***TRANSITIONAL PART 3A ASSESSMENT
Concept Plan Modification MP05_0086 MOD 4
and
Project Application MP11_0046
for
Stage 3 Residential Development, Buildings
11 to 17 at 61 Mobbs Lane, Epping
(Former Channel 7 Site)***

Director-General's
Environmental Assessment Report
Section 75I of the
Environmental Planning and Assessment Act 1979

May 2013

Figure 10: Comparison of Approved and Proposed Building Envelopes
(pink envelopes depict the envelopes approved under MP05_0086 MOD 2)

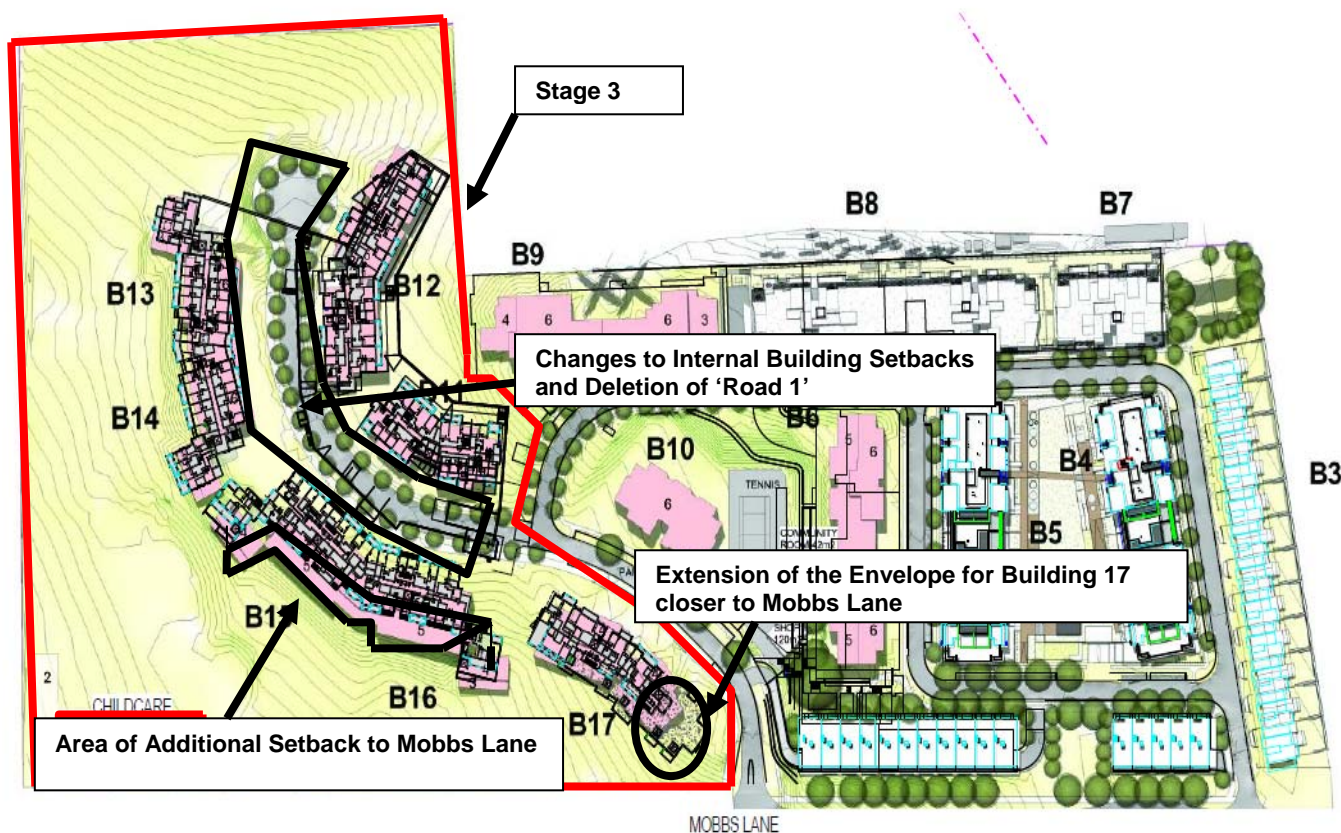
- Reconfiguration of the southern and western elevations of Building 12;
- Increasing the height of the wings adjacent to the south-western and south-eastern corners of Building 13/14 from part three, part four-storey to wholly four-storey;
- Relocation of Building 15/16 to the north of its approved location; and
- Elongation of Building 17, and a reduction in its setback to Mobbs Lane;

The department has reviewed the proposed modifications to the building envelopes and supports the relocation of buildings 11 and 12 and 13/14 on the basis that the modified building envelopes would remain compliant with the minimum building separation distances recommended in the *Residential Flat Design Code* and would not result in any adverse amenity impacts when viewed from Mobbs Lane or the adjoining reserve. In addition, the department supports the proposed modifications to the envelope of Building 15/16 on the basis that the modifications will increase the separation between the six storey components of the building and Mobbs Lane by approximately 8 metres (creating a total setback of between 48 metres and 85 metres for the six storey component of the building).

The department does not support the proposed modifications to the envelope of Building 17 on the basis that the above ground portion of the basement, the podium, and the north-eastern corner of the building are not sufficiently setback from Mobbs Lane to mitigate the bulk and scale of the development (setback of 15 metres to the eastern wall of Building 17 currently approved, 4.7 metres to the edge of the elevated podium and 7 metres to the balconies on the eastern elevation of Building 17 proposed).

Figure 13: Portions of Building 15/16 with Potential to Accommodate Additional Height

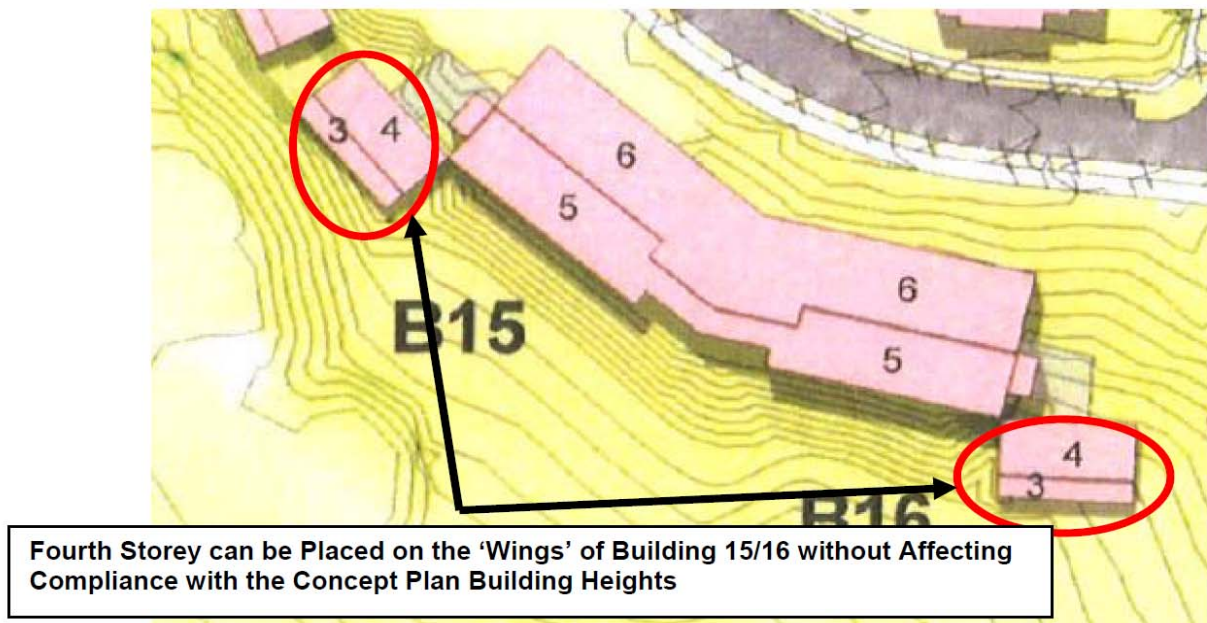
The department notes that the redesign of apartments UG84, UG85, U184, U185, U284 and U285 would result in the loss of three apartments (one on each level). In this regard, the department considers that it would be possible to 'recover' these apartments by utilising the residual floor space available within the wings on the south-eastern and south-western ends of Building 15/16 (see **Figure 13** below). The department has recommended conditions to facilitate the recovery of these apartments whilst ensuring compliance with the unit mix and car parking rates specified in the Concept Plan and the requirements of SEPP 65.
